Subject: Dayco Corporation/L. E. Carpenter Superfund Site
USEPA ID No. NJD002168748
Response to Agency Comments on the Additional Wetland Delineation
Sampling Results

Attachment 1
Responses to EPA and NJDEP Comments on
Additional Wetland Delineation Sampling Results
Dayco/LE Carpenter Corporation Superfund Site, Wharton, NJ

PROJ. NO. 212321.0000.03
FILE NO. 212321.0000.03.01.dwg
FIGURE 1

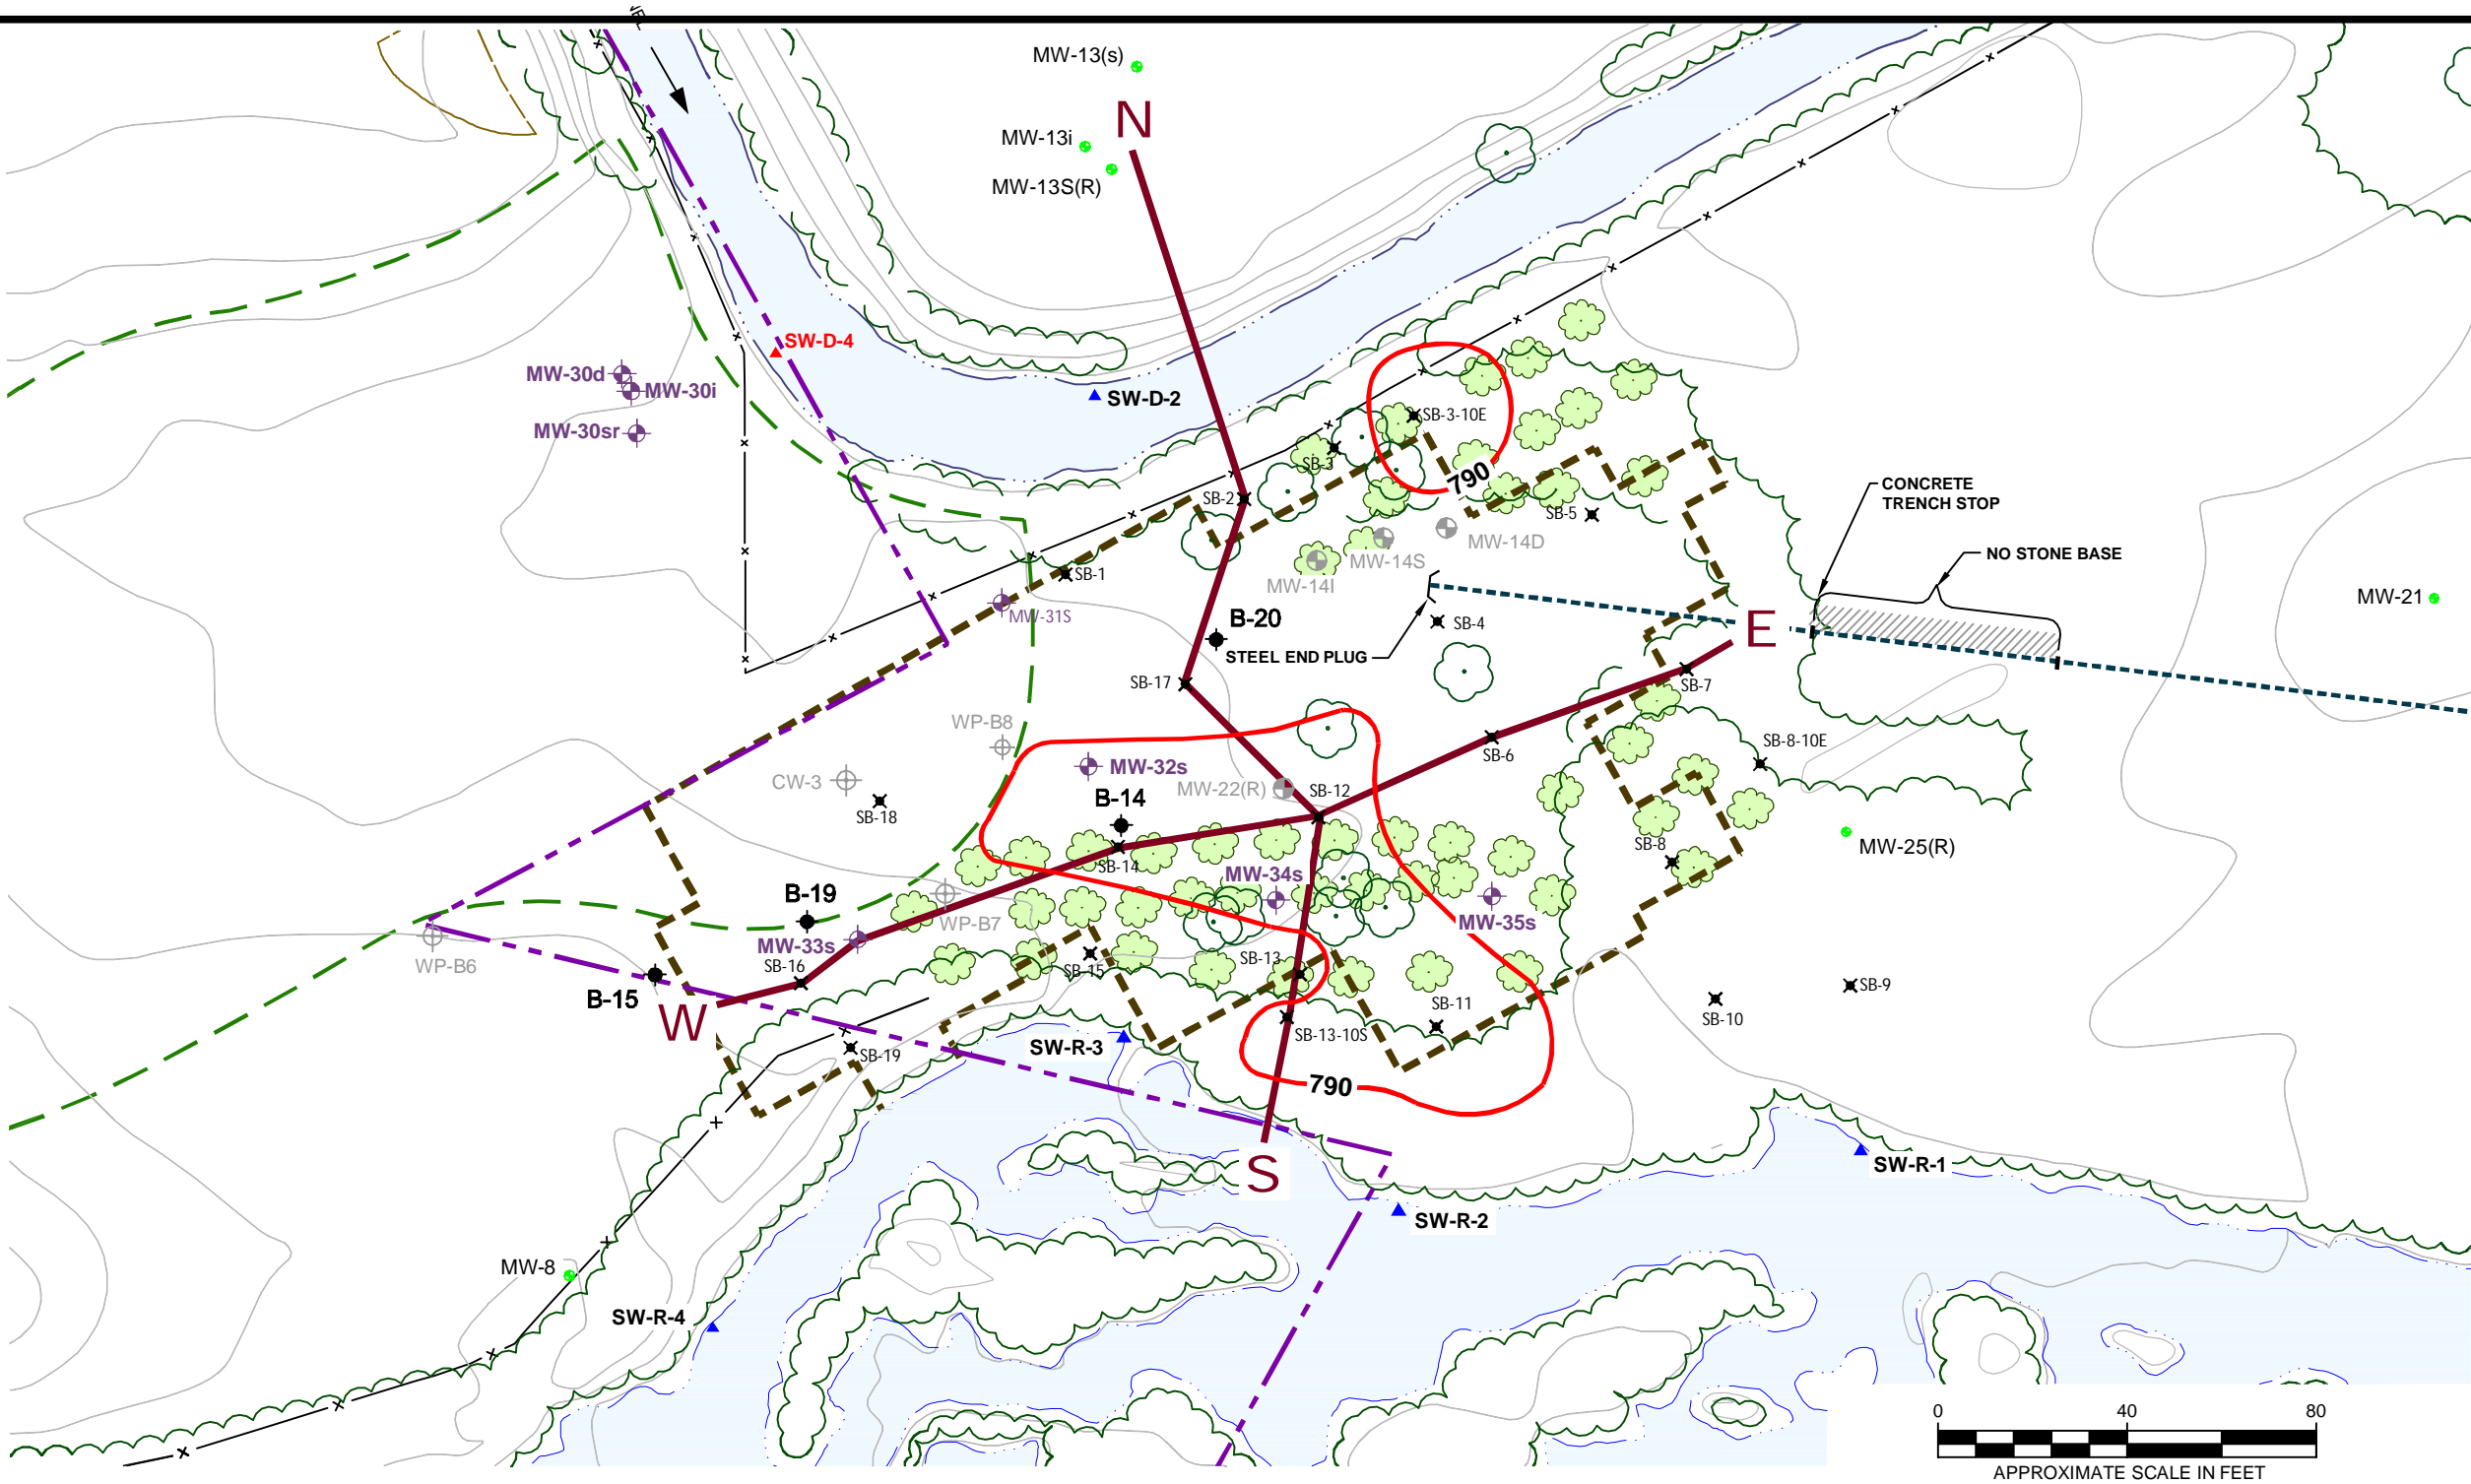
8. ***Figure 1, submitted as part of Progress Report No. 39 is not an adequate representation of the area or sampling results. The work plan should include confirmation that the sampling results will be reported in cross sectional and surface view maps that are of sufficient scale and detail for focus on the area of concern. The scale used in Figure 1 was insufficient.***

The Figures presented in Attachment 2 have been prepared at a scale (1 inch equals 40 feet) that better focuses on the wetland area. As previously discussed, the requested cross-sections are included as Figures 7 and 8.

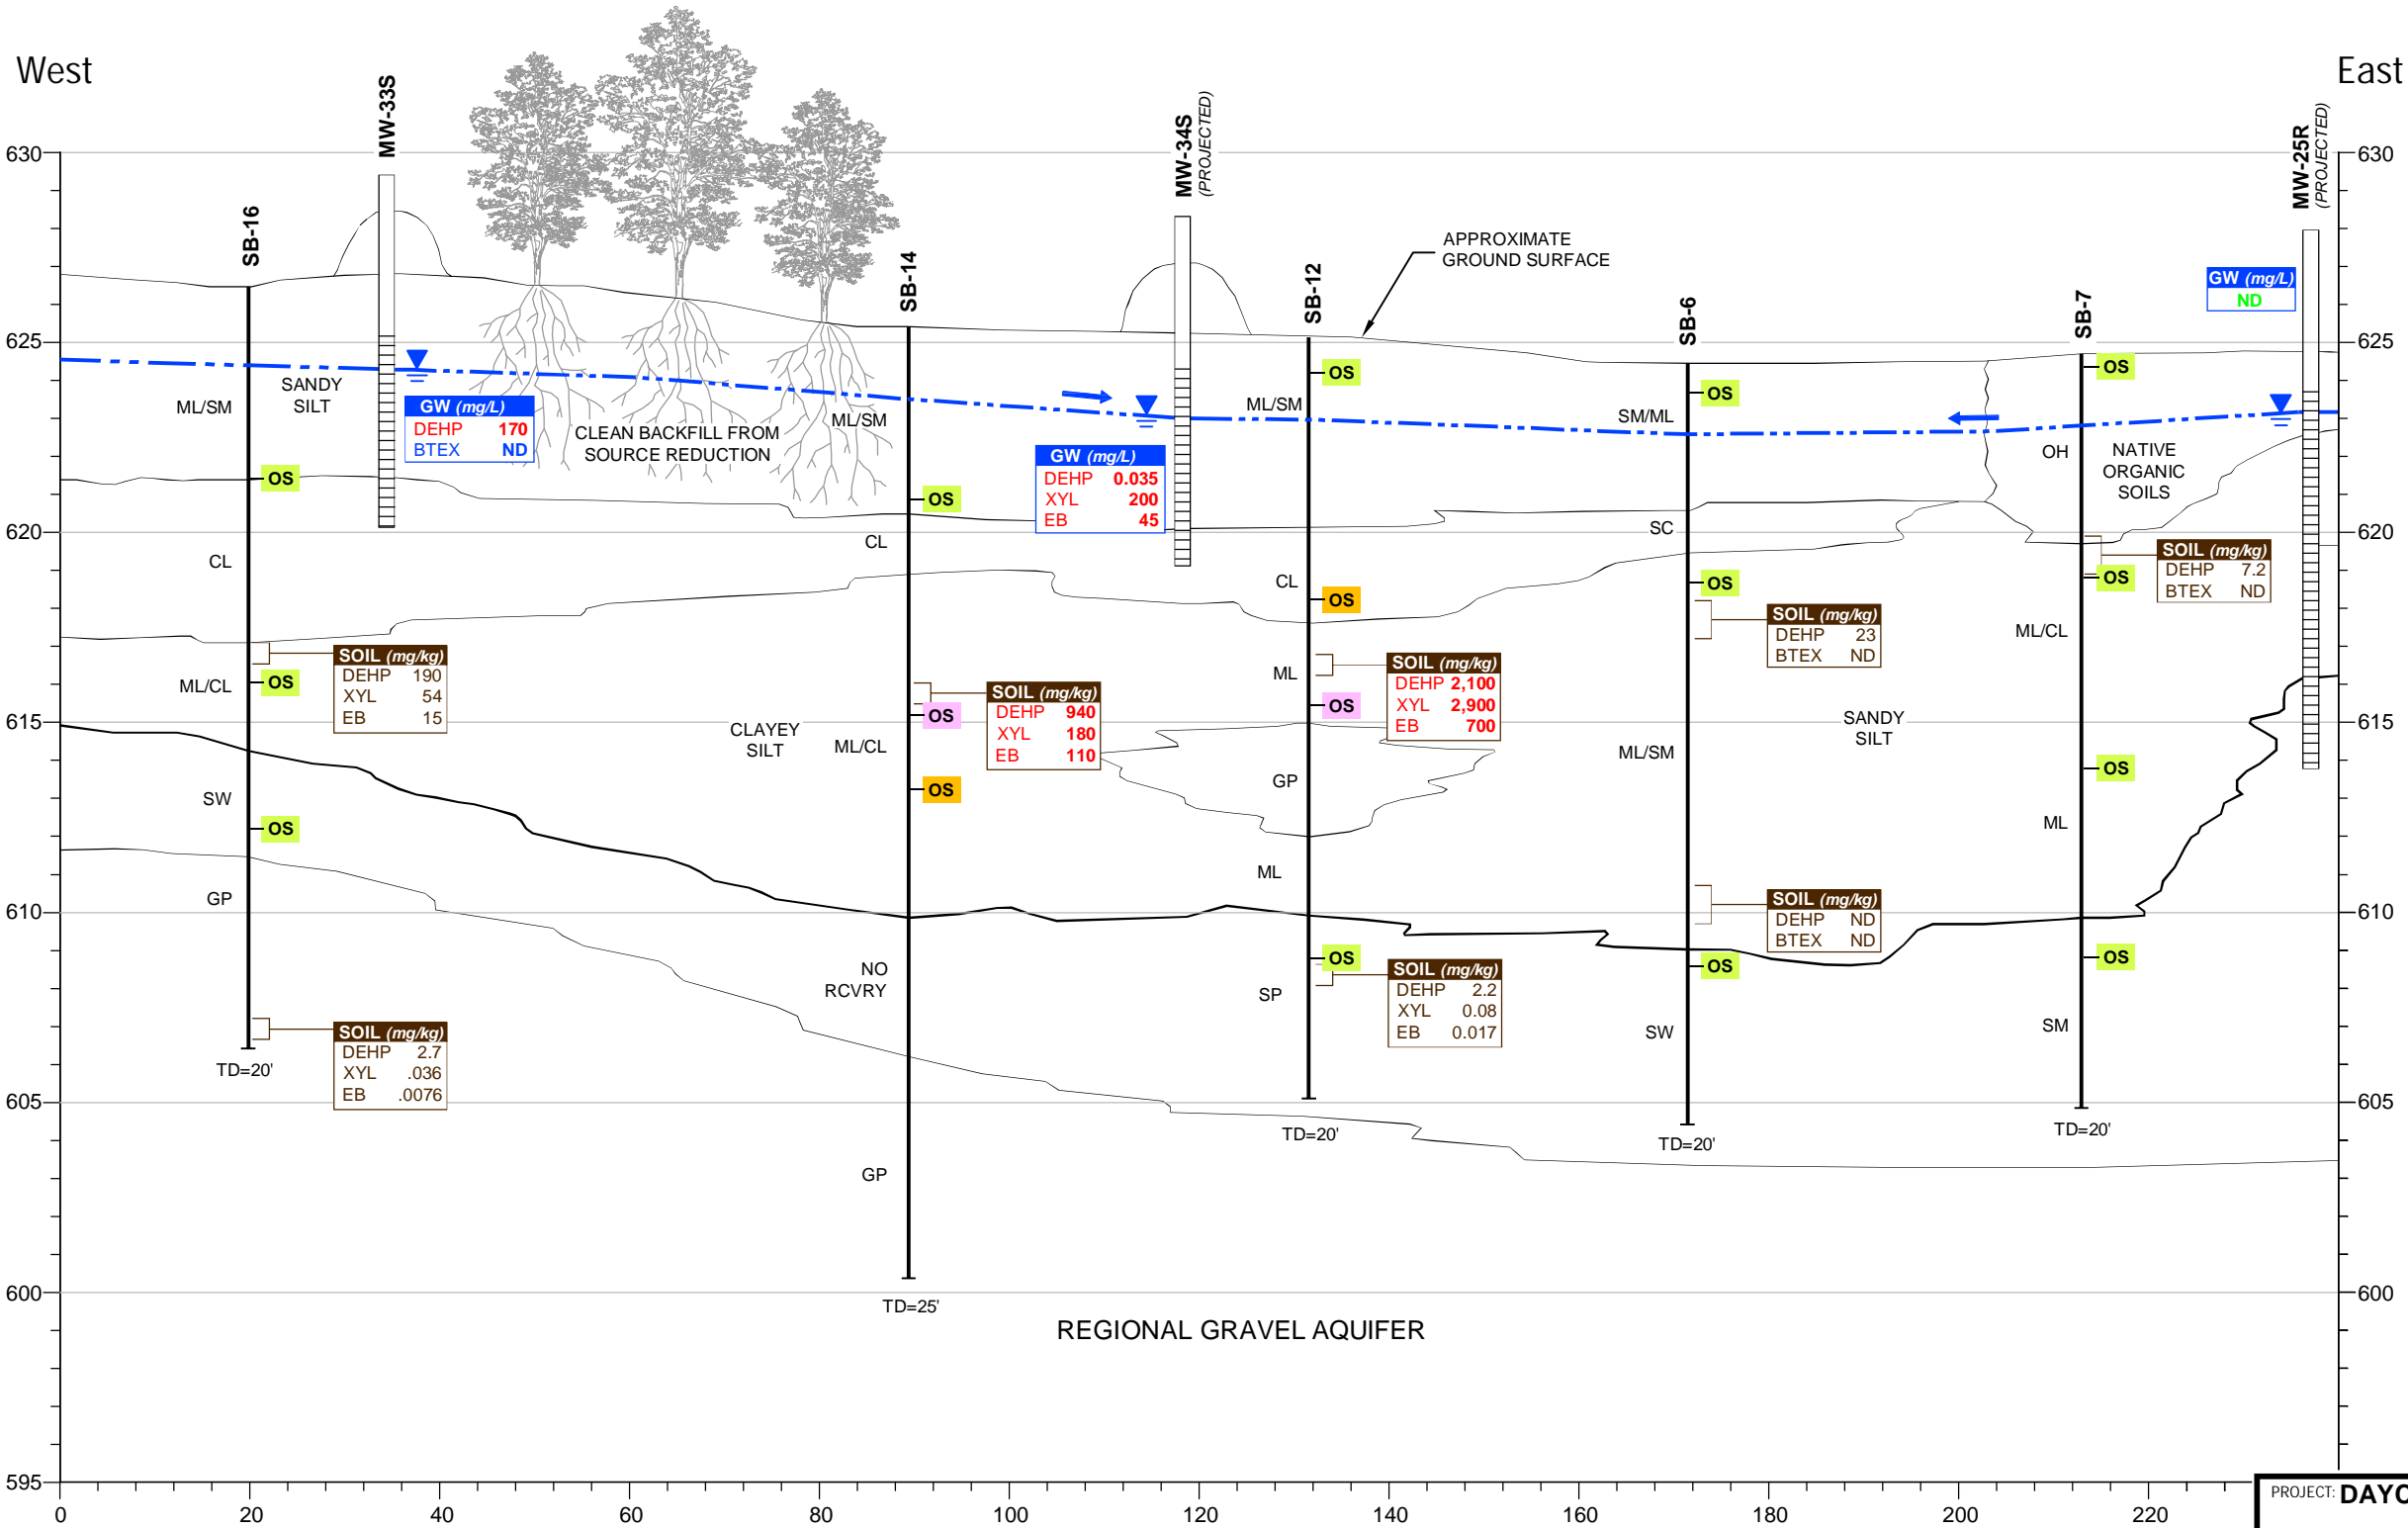
- 3. Continuous borehole profile sampling of both soil and groundwater is needed to fully and accurately delineate the both the lateral and vertical extent of the contaminants.***

4. ***Samples must be collected at sufficient depth at each location to clearly demonstrate the bottom elevation of the impacted area(s). Targeted depths for all boring and sampling should be a minimum of 30 feet bgs.***

The MW-30 RI Report did not include cross sections for the area. We have prepared and attached two cross sections using data from the MW-30 Supplemental RI; Figure 7

is a west-east cross section through the area and Figure 8 is a north-south cross section. Figure 9 is a schematic drawing that portrays a conceptual regional and site specific model of groundwater flow. The strong upward vertical gradients that exist within the Site as shown on the conceptual model diagram are supported by on-site head data from existing and historical well clusters.

The attached cross sections confirm that the 20-30 foot depths of the MW-30 Supplemental RI soil borings, coupled with historical data, are sufficient to establish vertical extent. Lower constituent concentrations observed in saturated soil samples may be due in part to drag-down phenomena during sampling. No significant contamination is expected to occur at deeper levels based upon data from other on-site well clusters. Namely, historical data from the previously abandoned MW-14 cluster located within the wetland area, as shown on the attached figures, and existing well clusters MW-28 and MW-30 reinforce the absence of impacts at deeper levels. The 2005 source reduction confirmed the shallow occurrence of the former product and product smear zone for the original primary source area.
